SECTION 00 91 15

ADDENDUM NUMBER 6

- 1.01 DATE: JANUARY 22, 2021**
- 1.02 PROJECT: ELMORE SPORTS MEDICINE RENOVATIONS**
- 1.03 PROJECT NUMBER: DCM NO. 2020452; PSCA NO. 2018**
- 1.04 OWNER: ALABAMA A&M UNIVERSITY**
- 1.05 ARCHITECT: NOLA | VAN PEURSEM ARCHITECTS, PC**

2 BUILDING SECTION
A-3.2 SCALE: 1/4" = 1'-0"

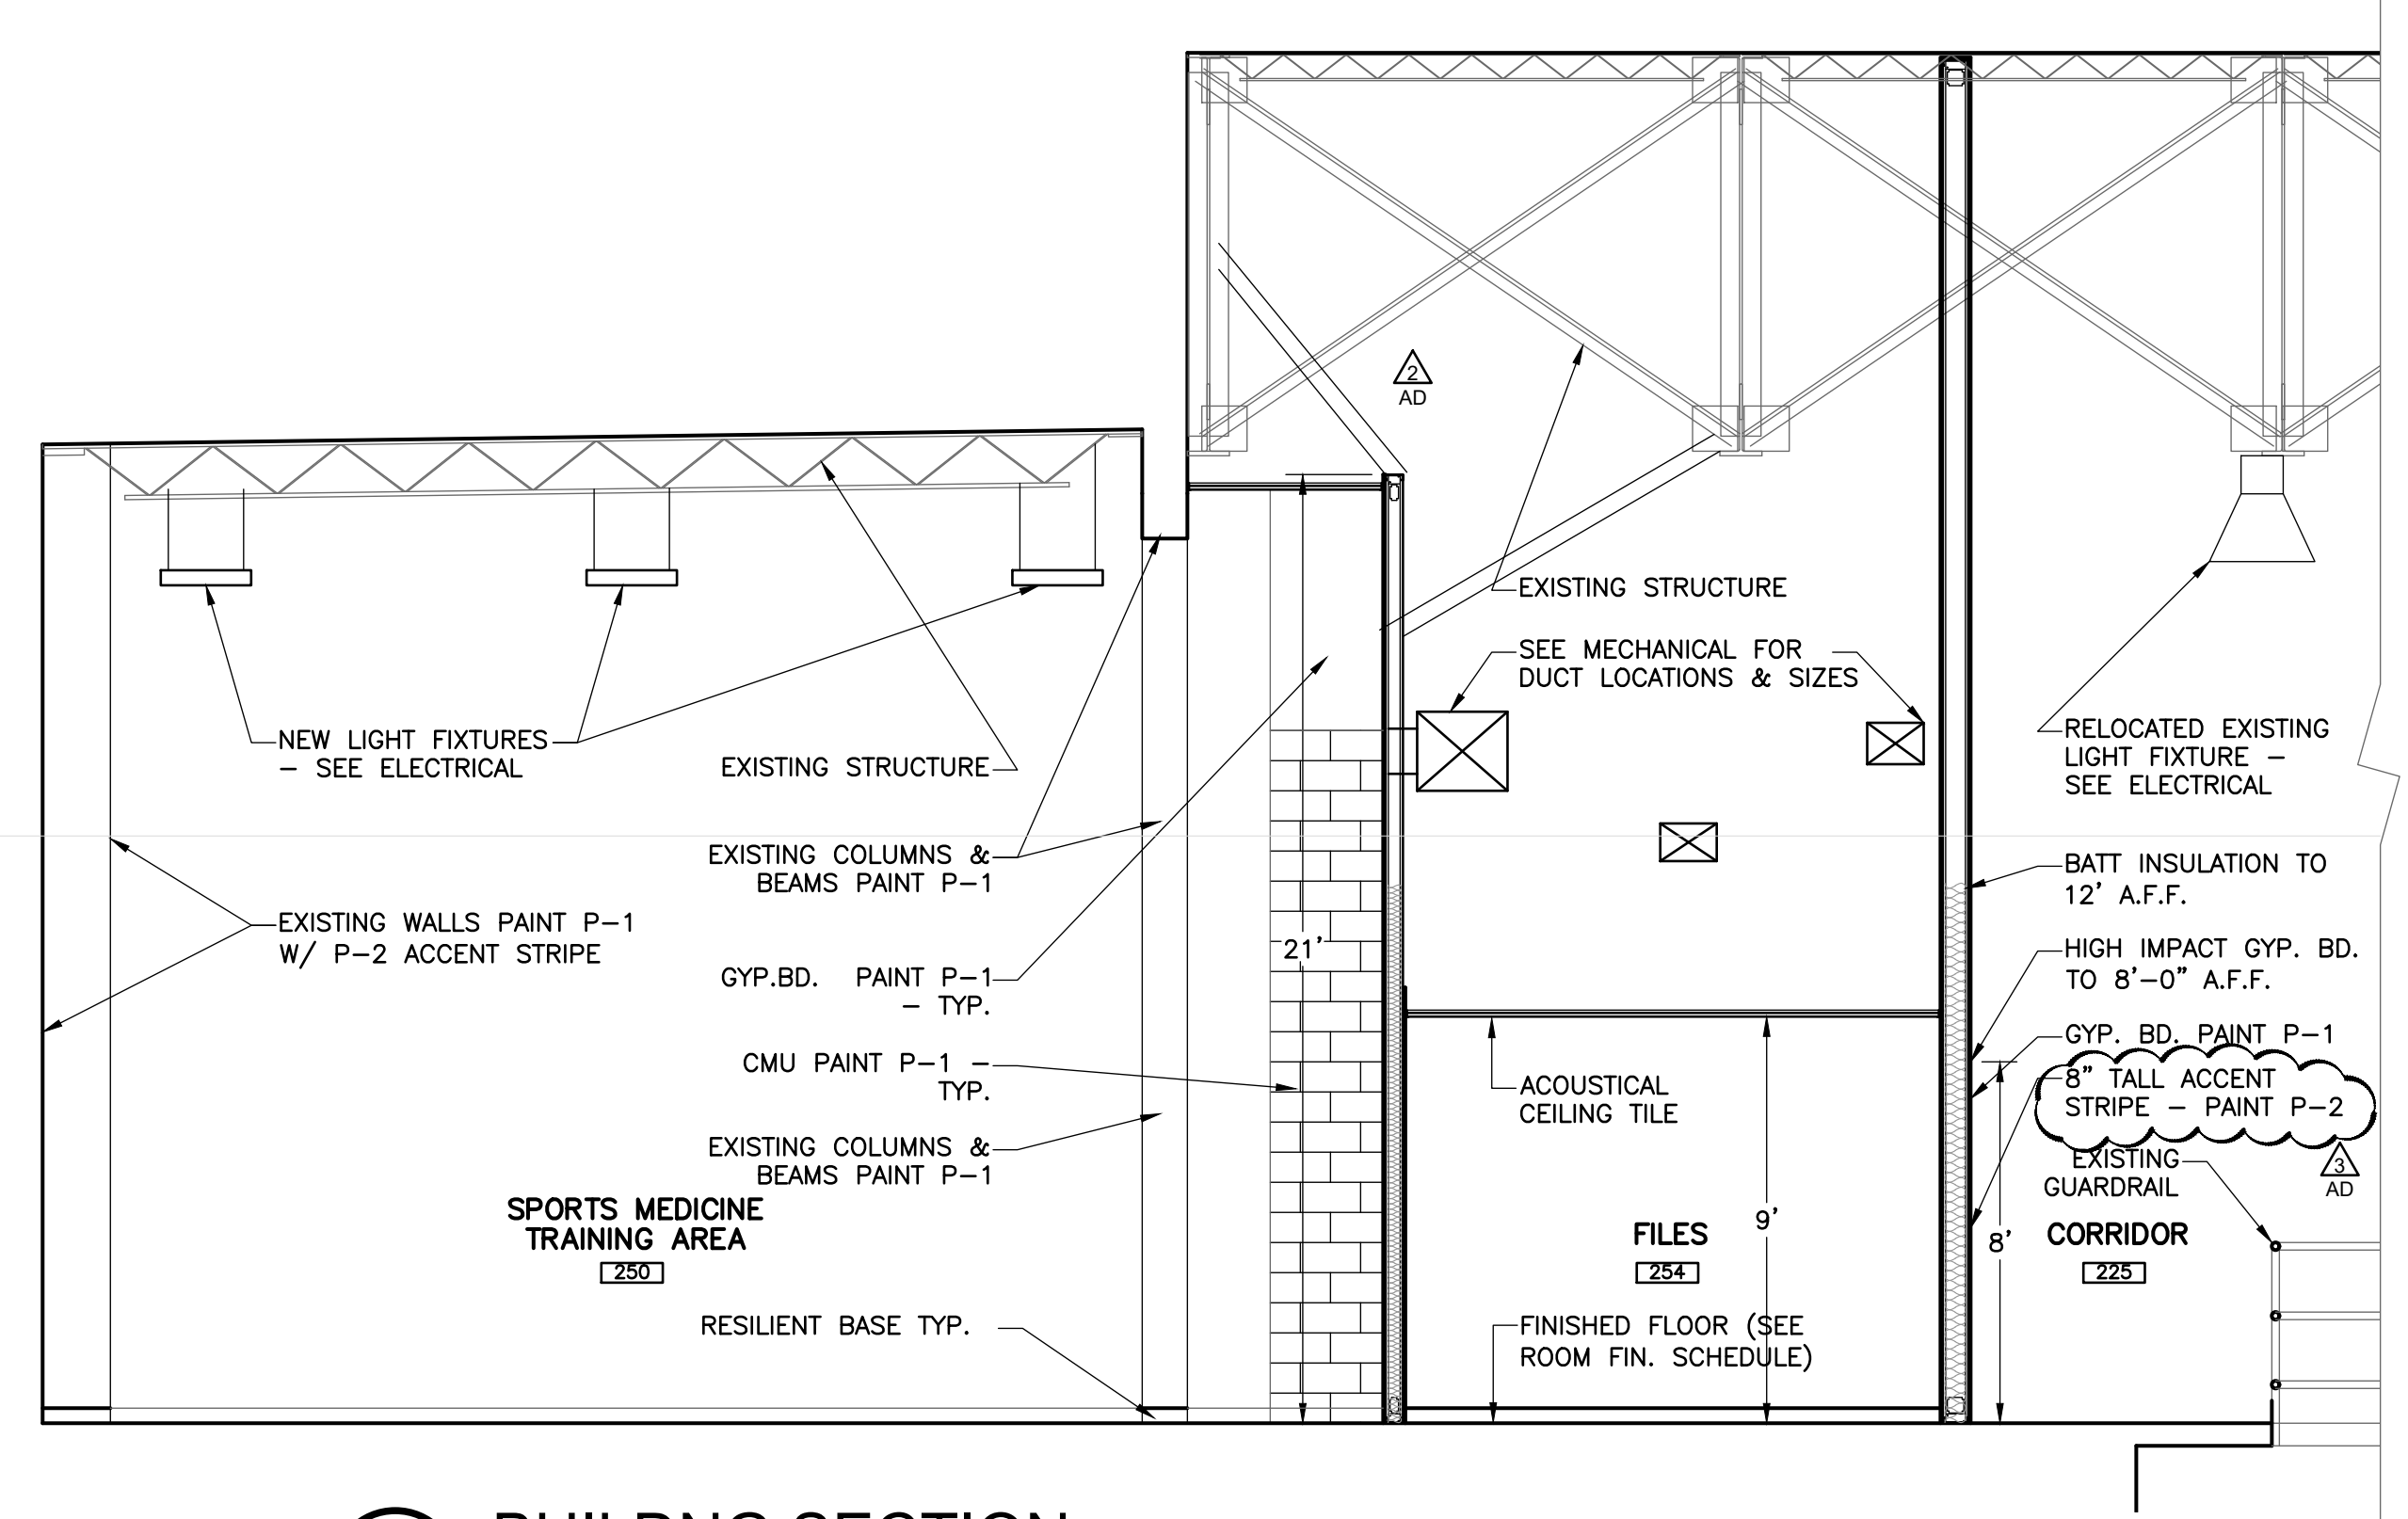
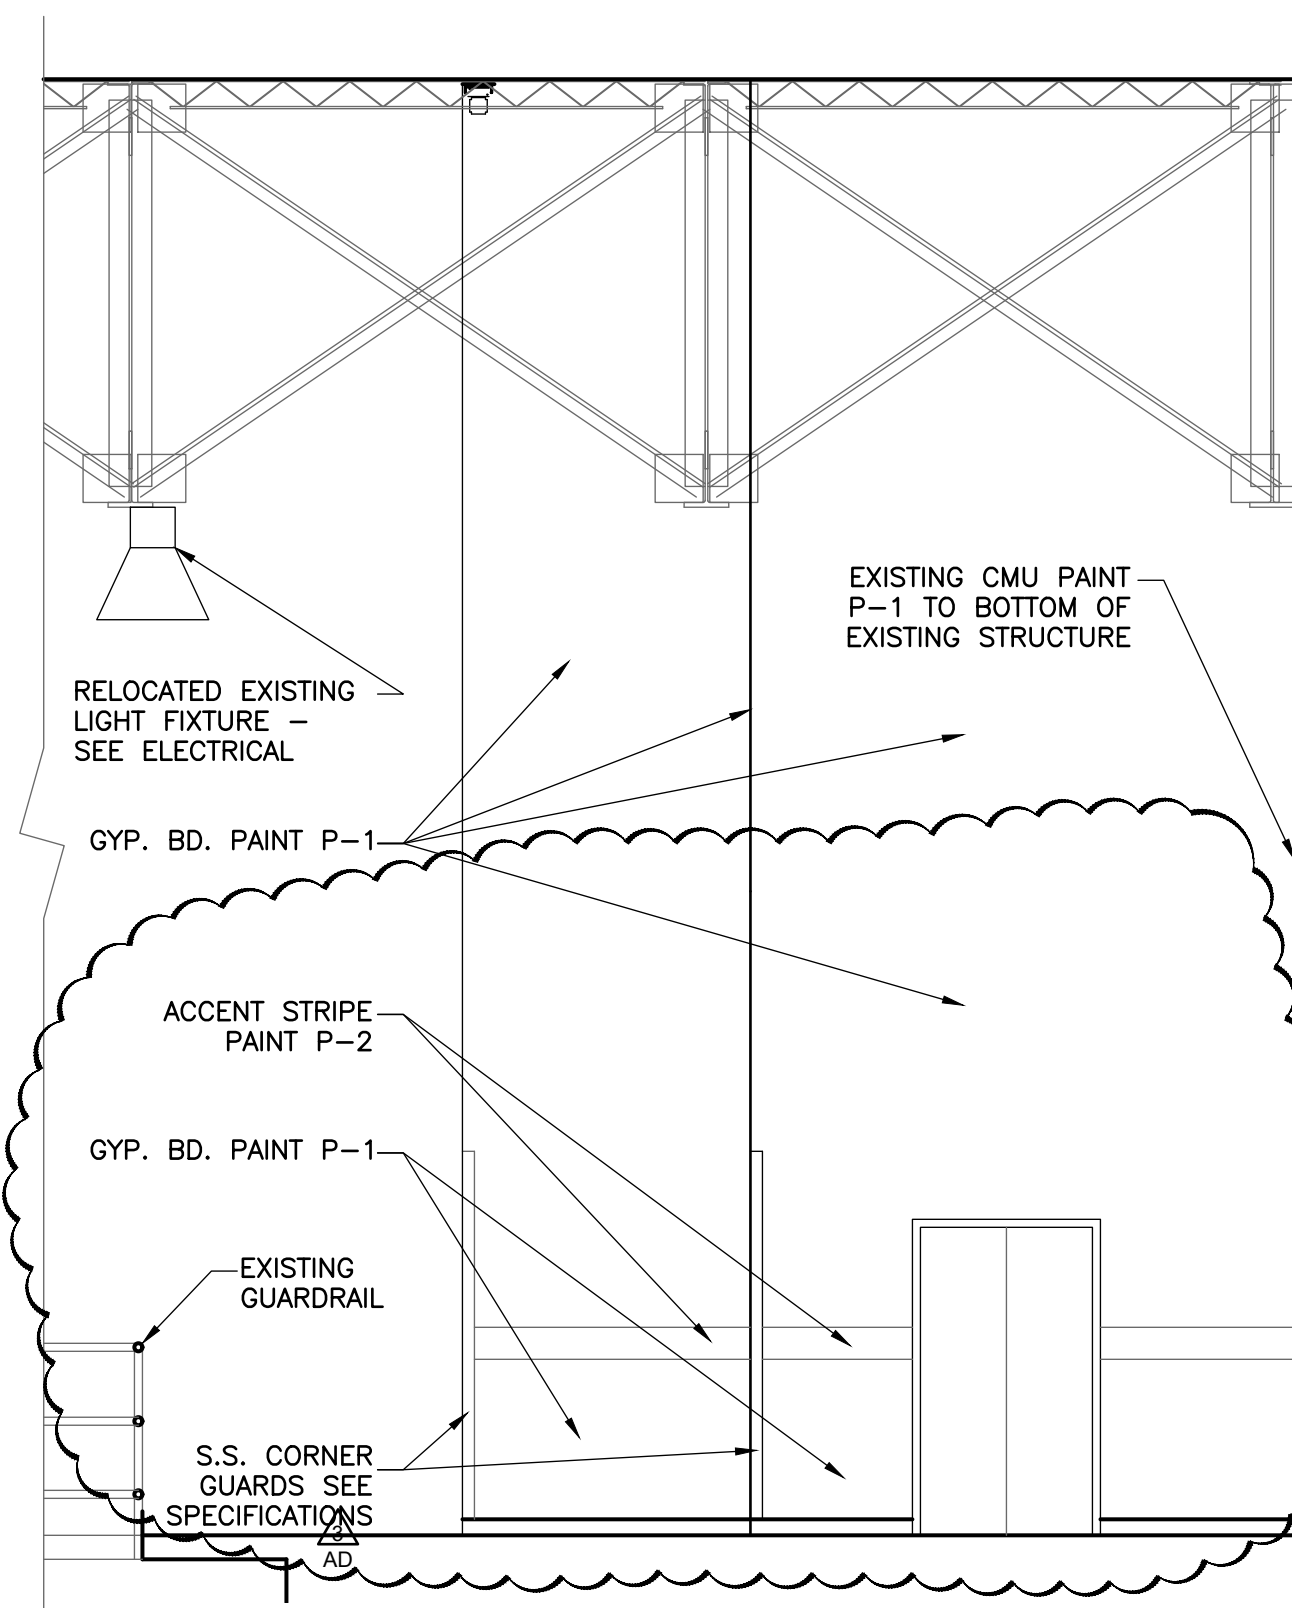
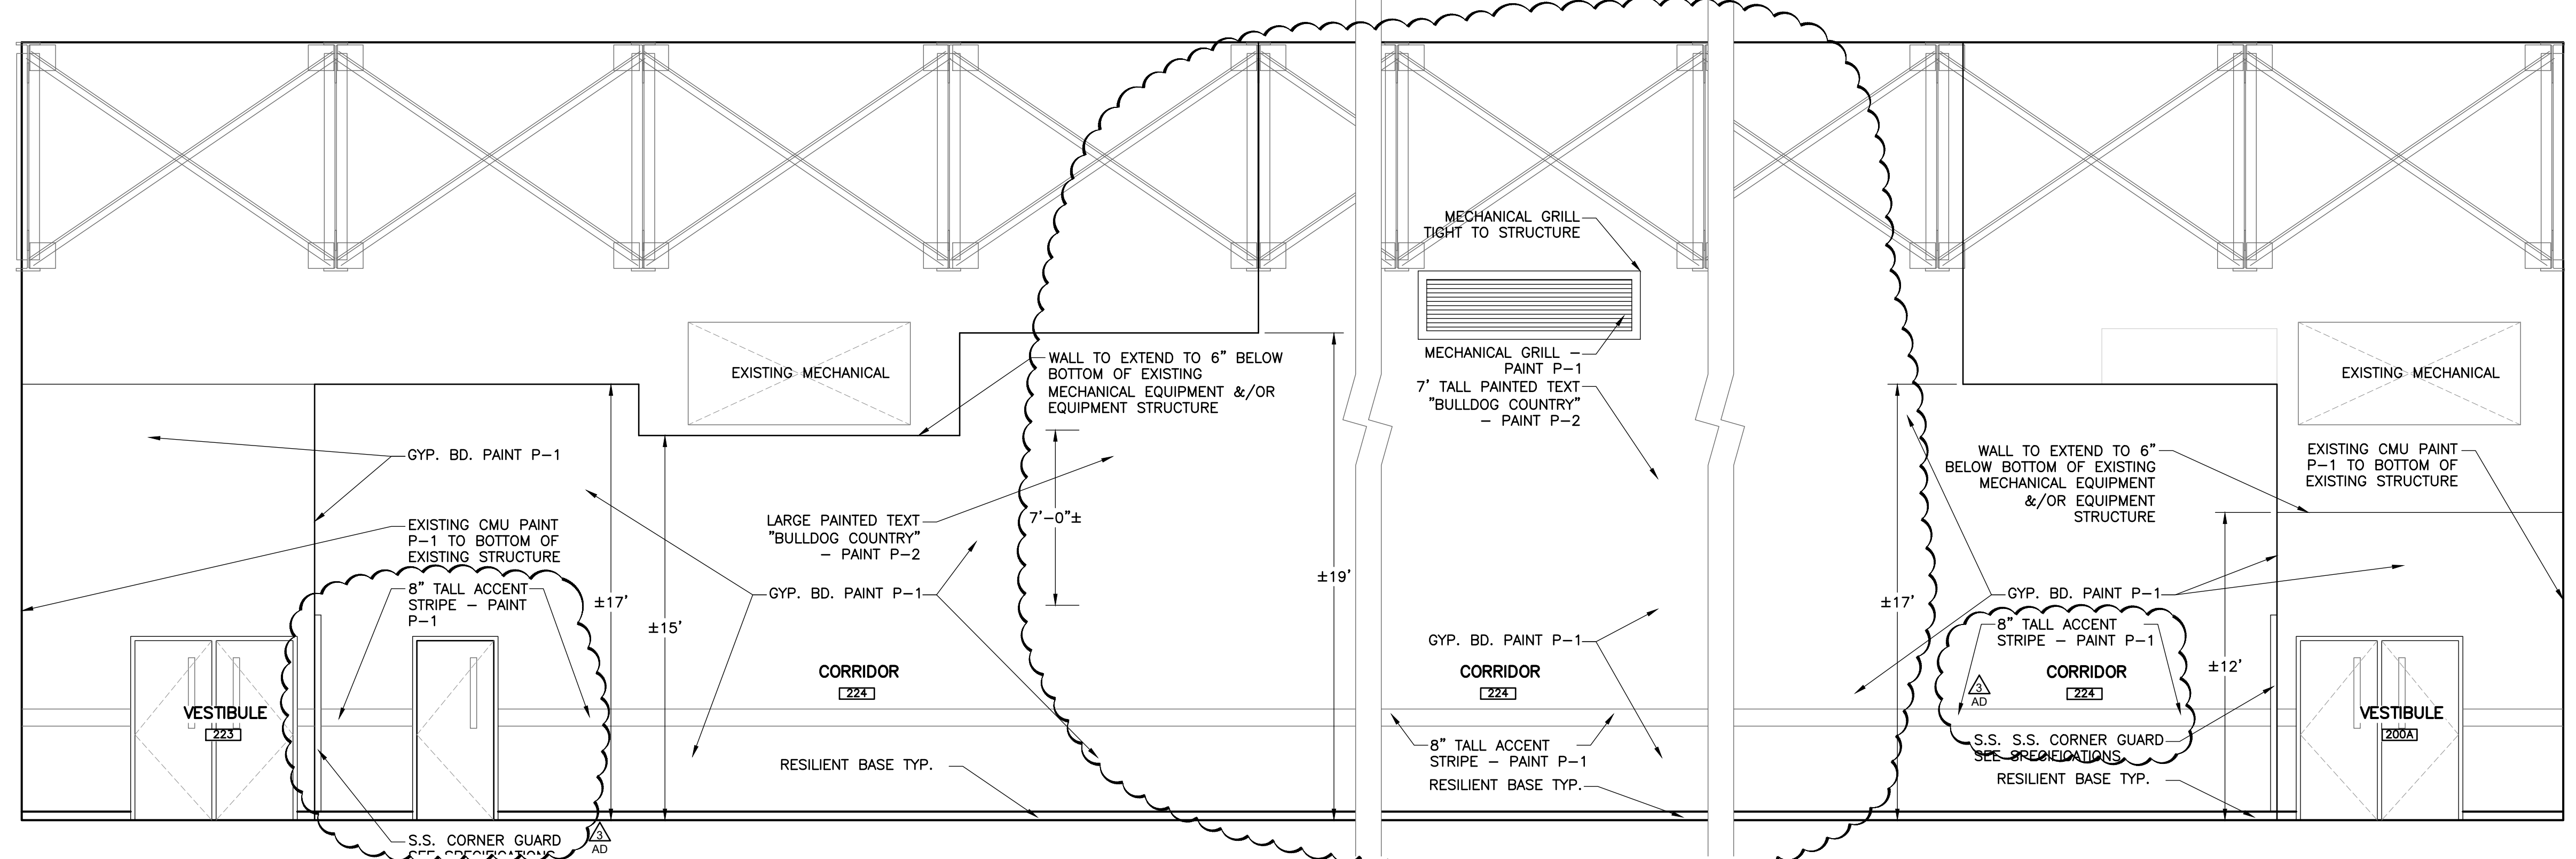
- A. Replace this sheet in its entirety. Revisions include the following:

1. Added painted accent stripe and large painted text.
2. Clarification of Mechanical grille location.
3. Revisions to elevator shaft wall finishes.
4. New soffit and lowered ceiling near elevator shaft.
5. Clarification of some corner guard locations.
